MAINE TURNPIKE AUTHORITY

ADDENDUM NO. 1

CONTRACT
2020.03

PORTLAND AREA WIDENING &
SAFETY IMPROVEMENTS
MILE 43.0 TO MILE 46.4

SHEET NUMBER: MOT-08
Addendum 1 Page 35
CONTRACT: 2020.03
16 OF 310

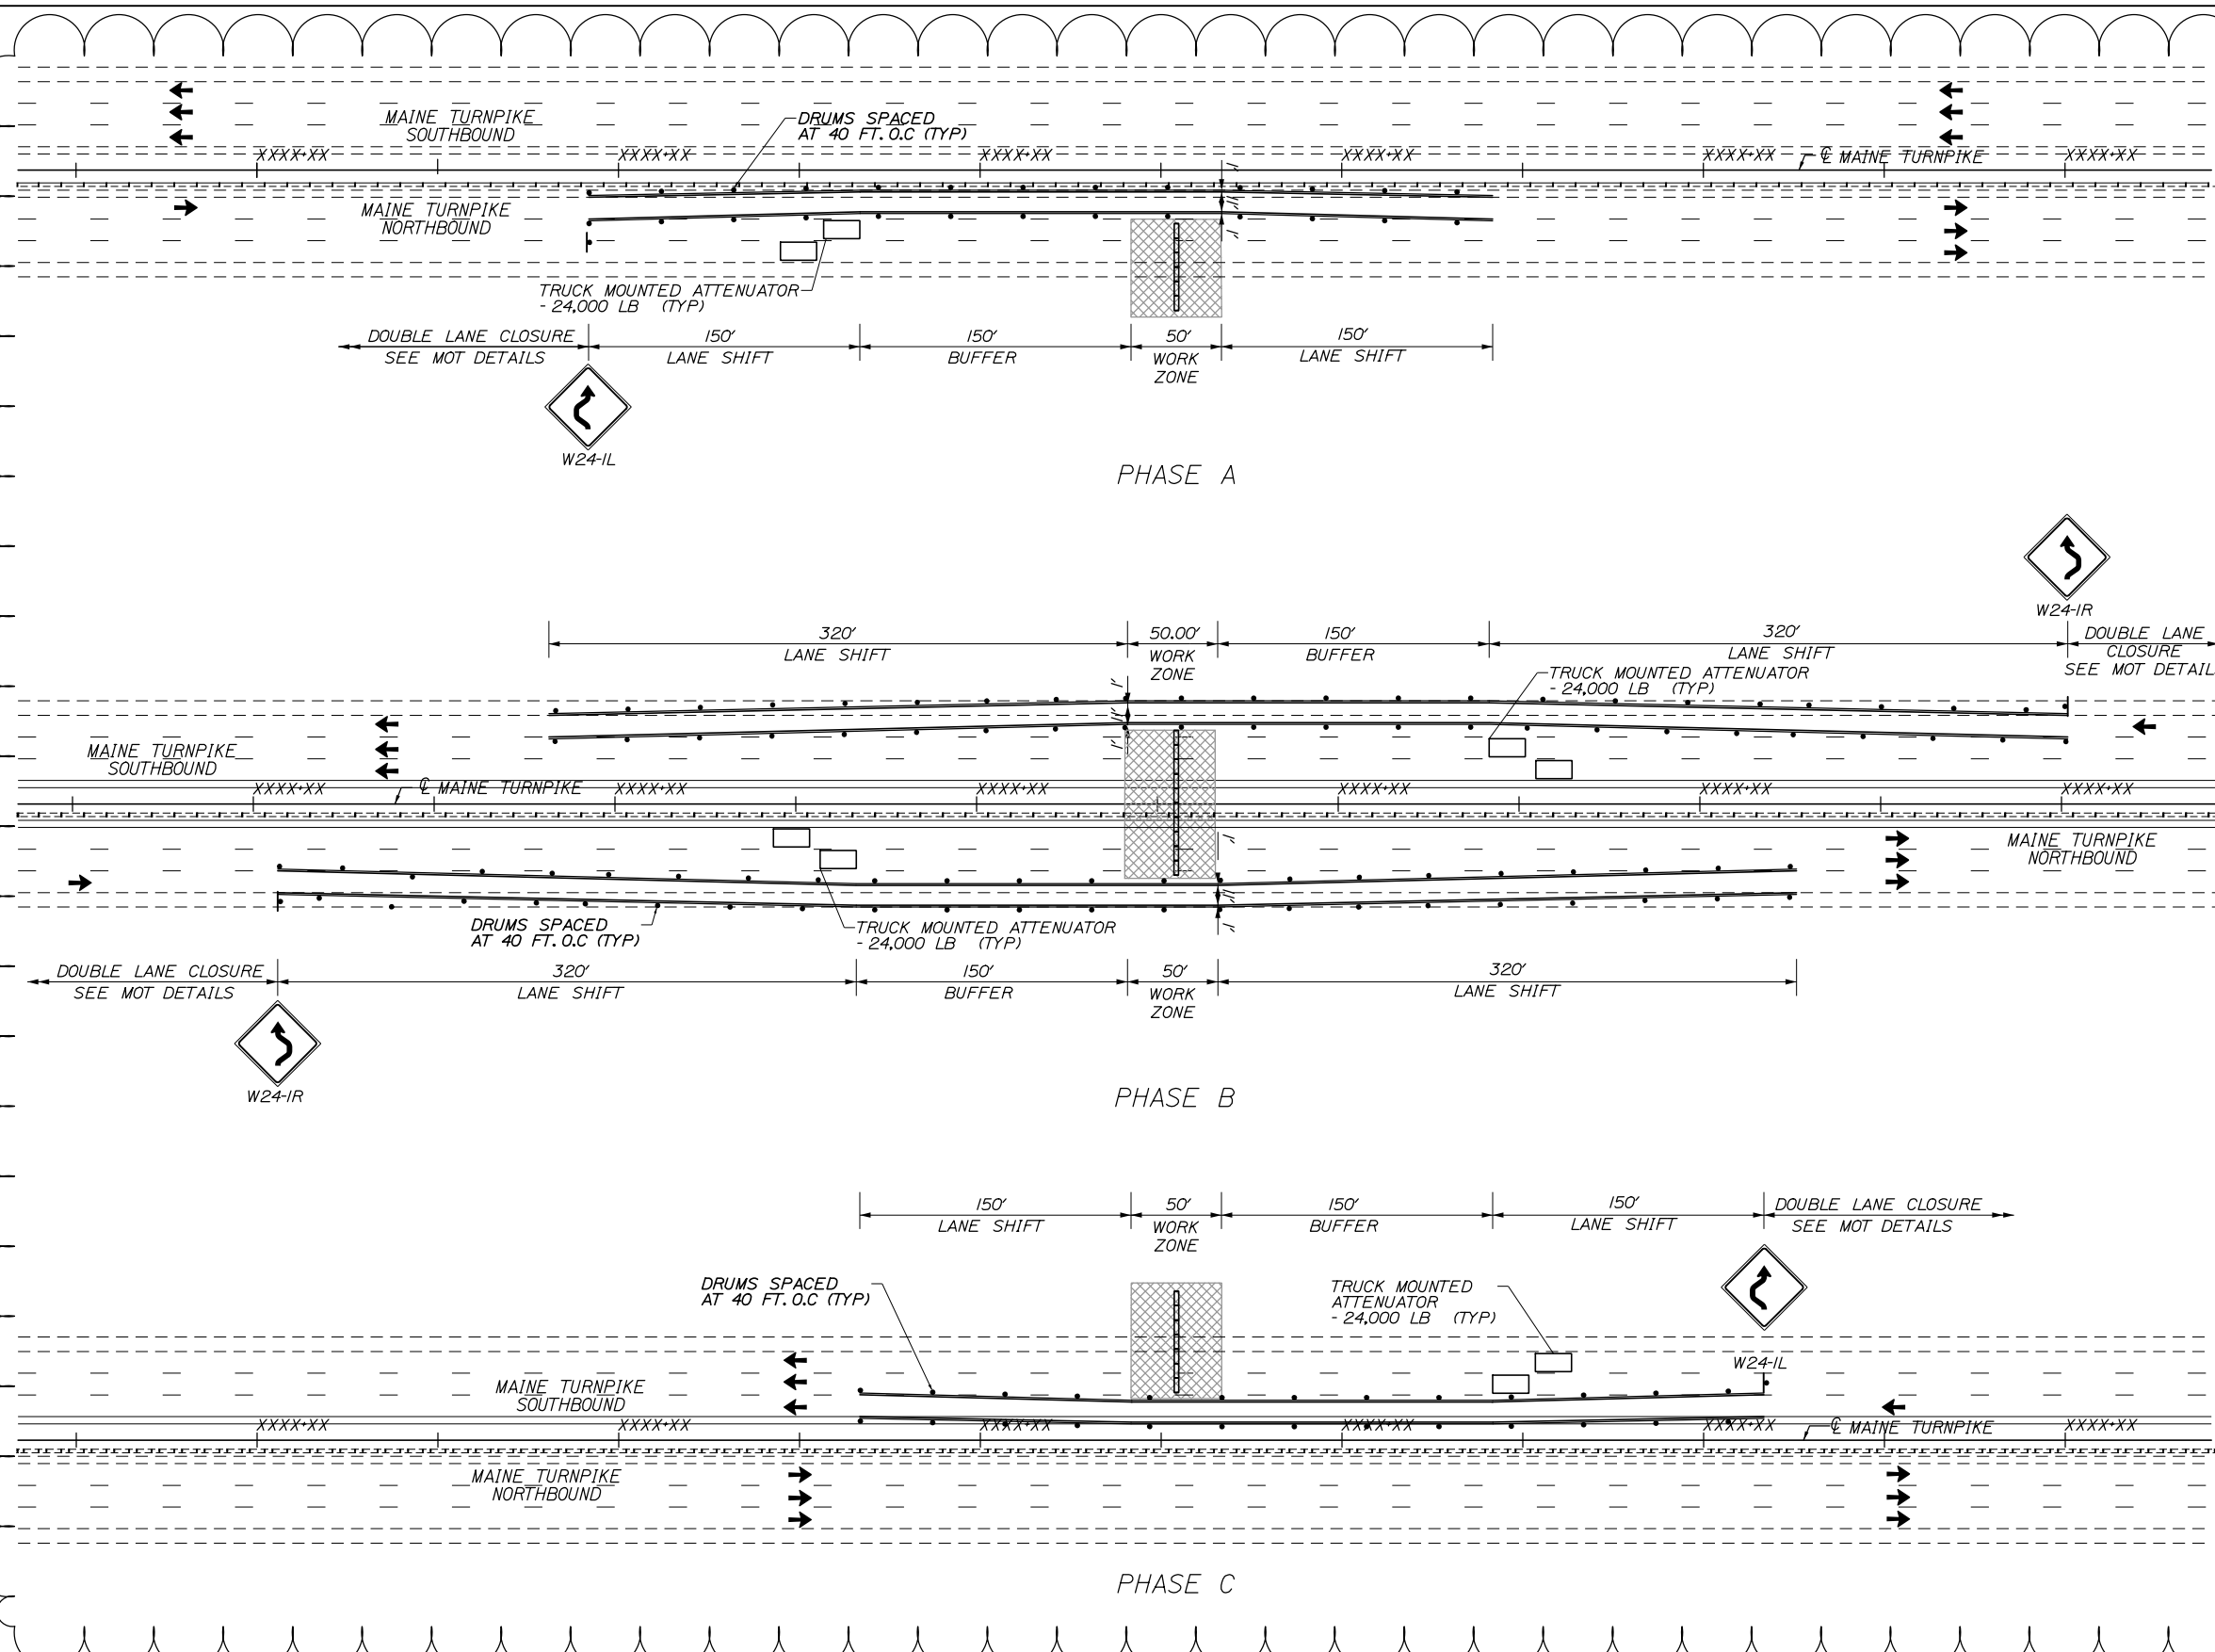
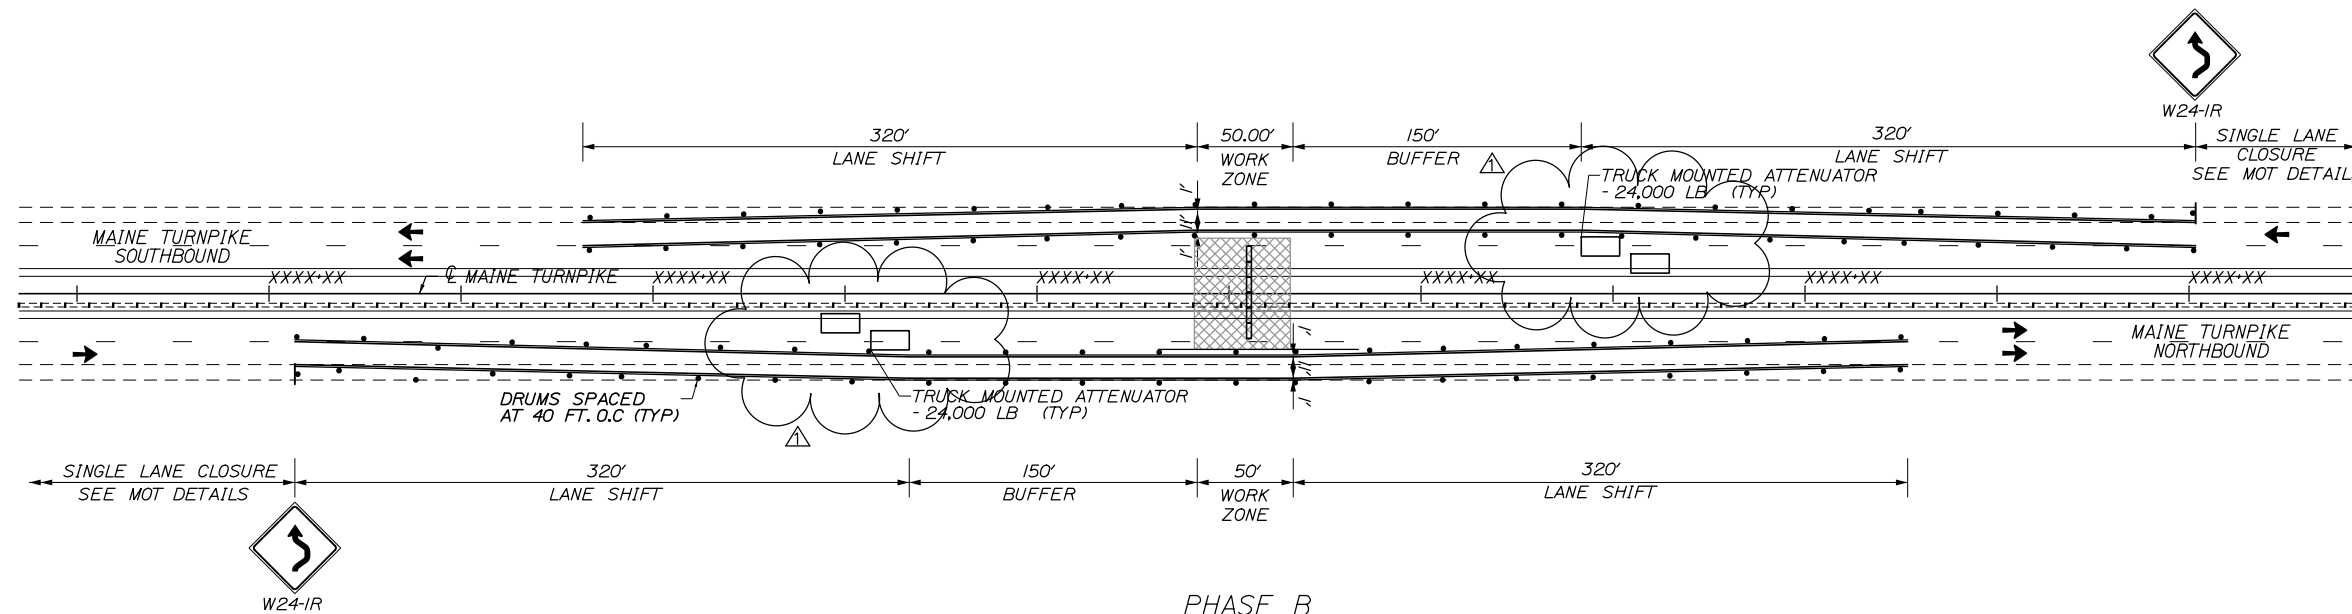
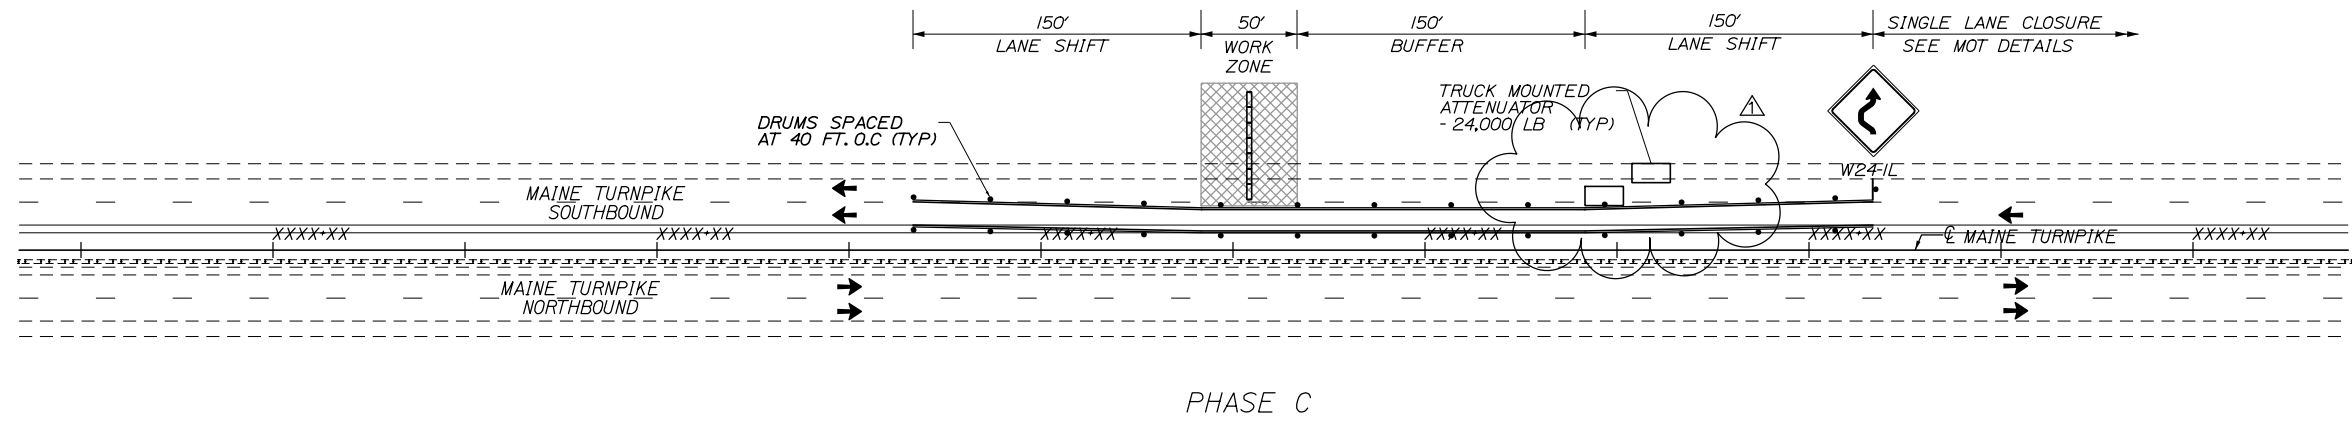
- Plan sheet 16, Maintenance of Traffic, Mainline Cross Culvert, MOT-08 is revised. See attached.
- Plan sheet 16A, Maintenance of Traffic, Mainline Cross Culvert, MOT-08A is added. See attached.
- Plan sheets 30 and 31 (MOT-22 and MOT-23) shall be revised with the following 'Pen and Ink' change. Change page reference from MOT-06 to MOT-07 in Note 1. "See MOT-07 shoulder closure detail for removal of Temporary Widening."

5. THE LENGTH OF PIPE INSTALLATION PER PHASE SHALL BE ENOUGH SO THAT THE SUBSEQUENT PHASE WILL NOT NEED TO DISRUPT THE ADJACENT TRAFFIC.
6. SHOULDER AND LANE WIDTHS INDICATED ON THIS SHEET ARE MINIMUM REQUIRED DIMENSIONS.

7. DURING PHASE 2 THE EXISTING MEDIAN GUARDRAIL WILL NEED TO BE REMOVED AND REINSTALLED PRIOR TO ADVANCING TO PHASE 3. SHOULD PHASE 2 TAKE MORE THAN ONE NIGHT, TEMPORARY BARRIER WILL NEED TO BE PLACED OR THE EXISTING GUARDRAIL REINSTALLED.
